[Docket No. FAA-2013-0146; Directorate Identifier 2012-SW-060-AD; Amendment 39-17559; AD 2013-16-21]

Airworthiness Directives; Agusta S.p.A. (Type Certificate Currently Held by Agusta Westland S.p.A) (Agusta) Helicopters

ACTION: Final rule.

2013–16–21 AGUSTA S.p.A. (Agusta):
Amendment 39–17559; Docket No. FAA–2013–0146; Directorate Identifier 2012–SW–060–AD.

Figure 1 to Paragraph (f)(1), T/R Blade, P/N 109-8132-01-111

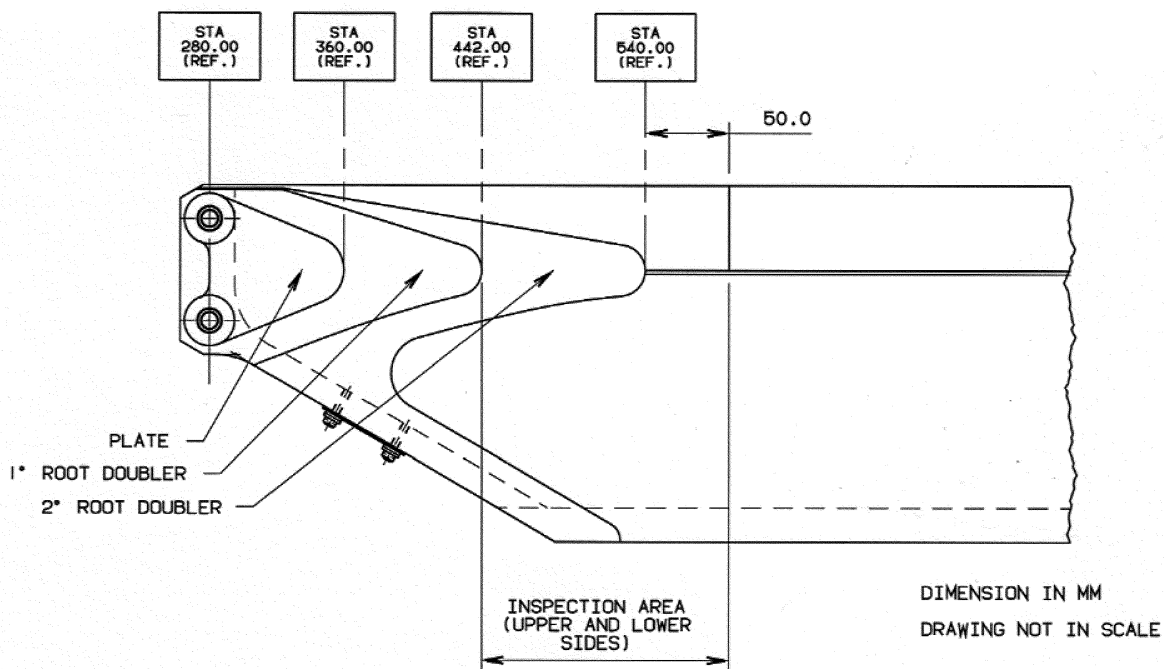
(1) Before each start of the helicopter engines, visually check both sides of each T/R blade for a crack in the inspection area depicted in Figure 1 to paragraph (f)(1) of this AD. This action may be performed by the owner/operator (pilot) holding at least a private pilot certificate, and must be entered into the aircraft records showing compliance with this AD in accordance with 14 CFR 43.9 (a)(1)–(4) and 14 CFR 91.417(a)(2)(v). The record must be maintained as required by 14 CFR 91.417, 121.380, or 135.439.
